March 19, 2019

Project No. 12091-01

**Subject:** *Preliminary Geotechnical Evaluation and Response to City Review Comments for Proposed San Pedro Distribution Center, 1599 W. John S. Gibson Boulevard, Los Angeles, California*

## **5.0 RESPONSE TO CITY REVIEW COMMENTS**

SCALE: 1"=40'  
40' 0 40' 80'

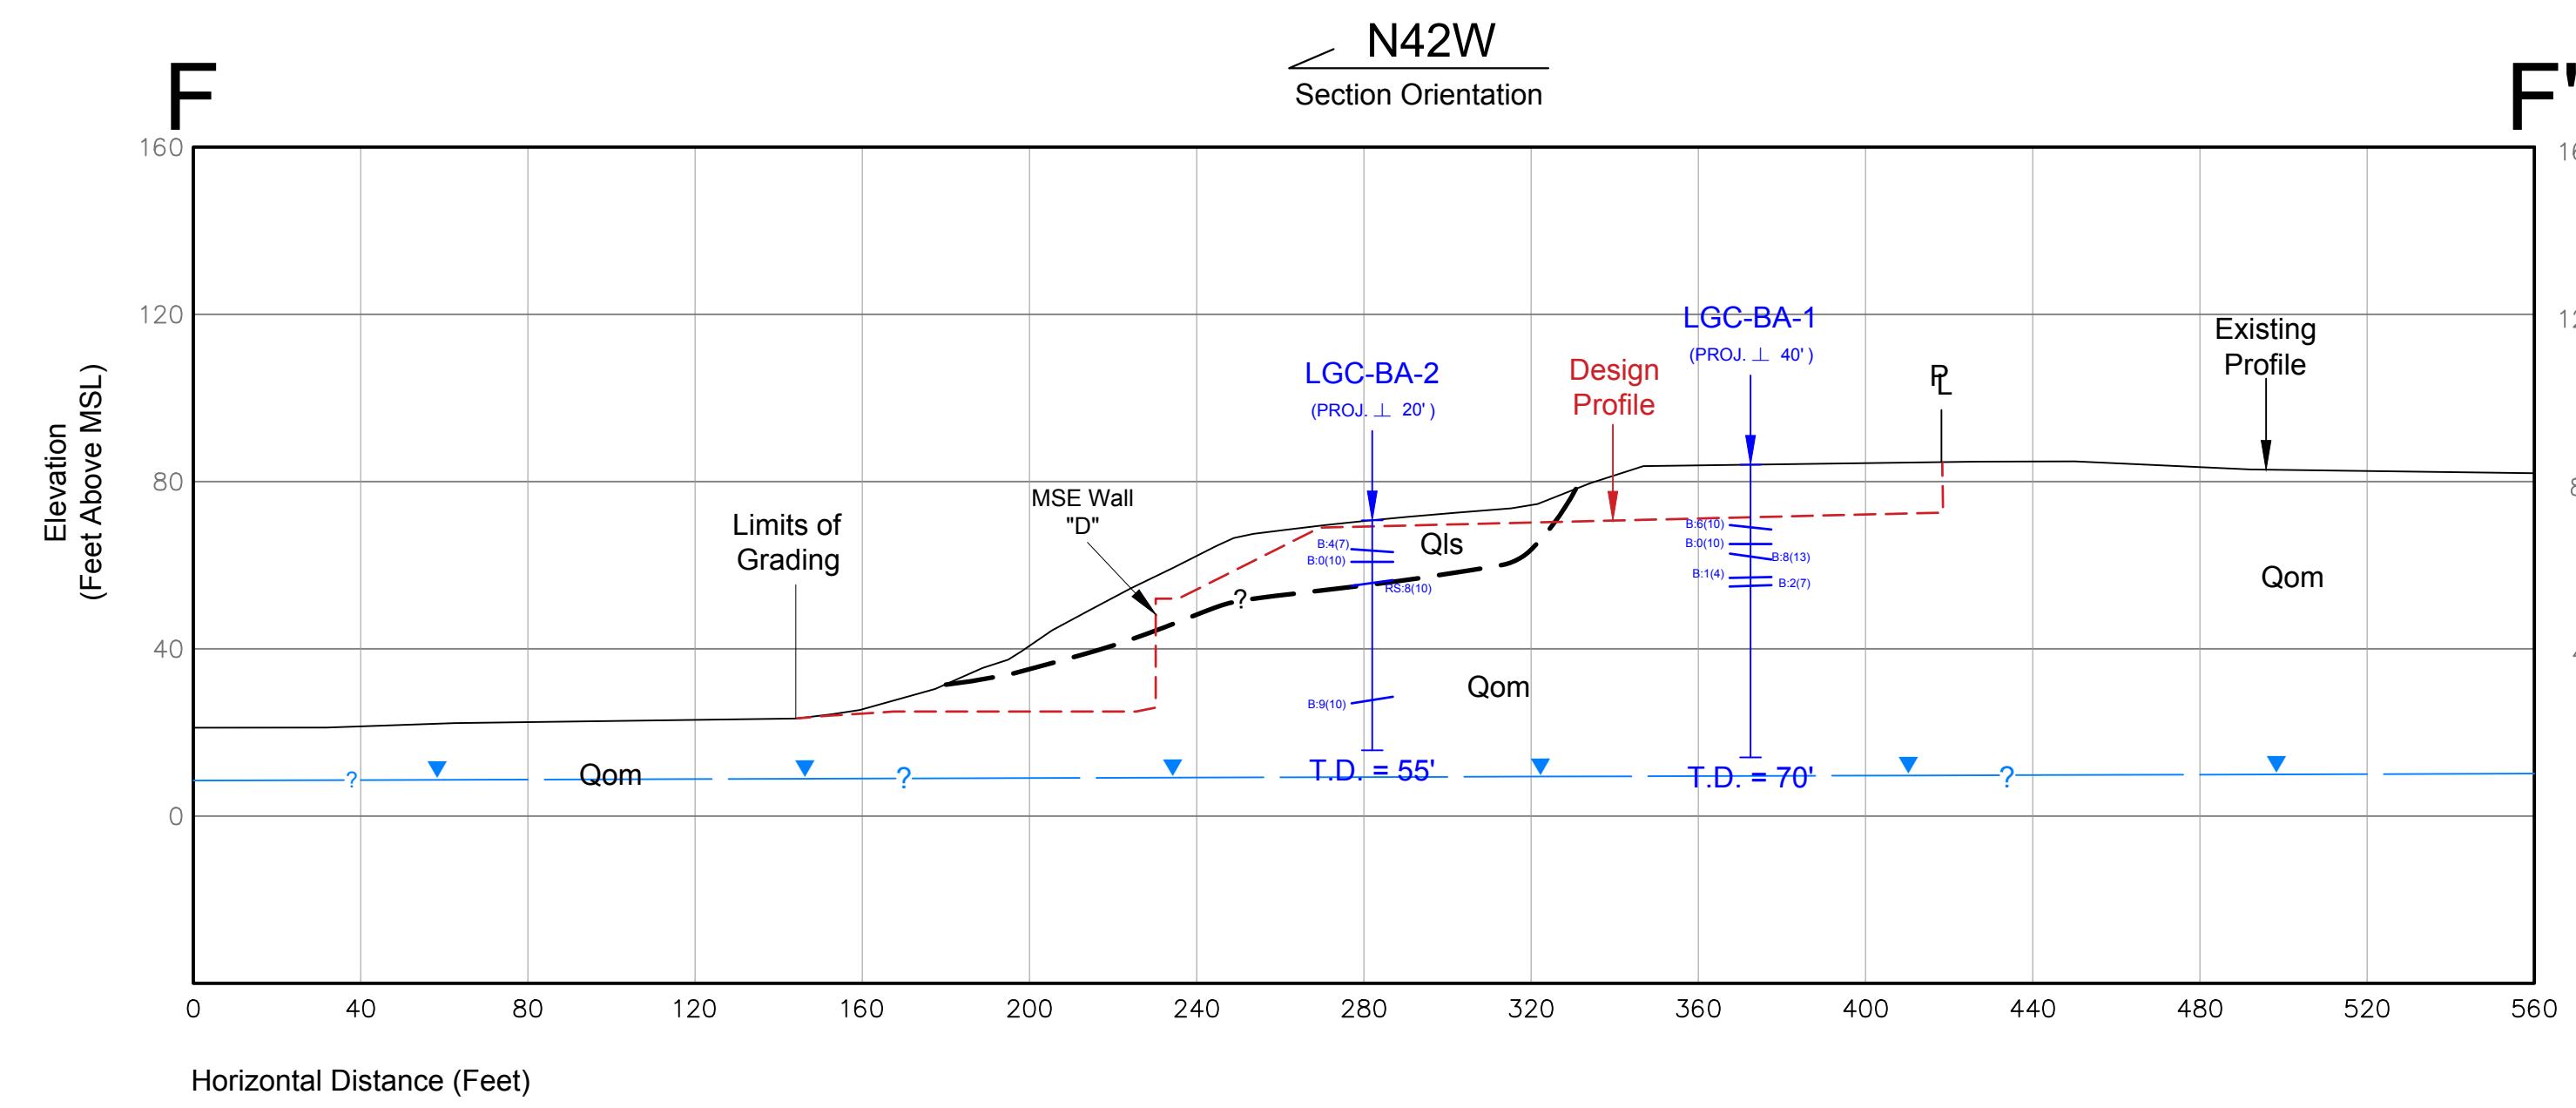
"Provide a geologic map and cross sections that are based upon conceptual grading or site development plans, to illustrate all proposed and existing contours relative to the planned grading and/or construction, along with all off-site slopes and conditions that could adversely affect the stability or safety of the site (7006.3.2). The geologic map and cross sections shall depict the top and bottom of slopes; lithologic contacts; bedding attitudes; locations of slumps, landslides, or faults relative to the subject site; existing and proposed topographic profiles; existing and proposed structures; and, required Code setbacks. (7006.3.2)"

"Provide geological cross sections illustrating existing and proposed grades and structures through the highest, steepest and geologically critical slopes."

Refer to the attached Geotechnical Map and Geotechnical Cross Sections (Sheets 1 through 5). No building structures are planned for the site.
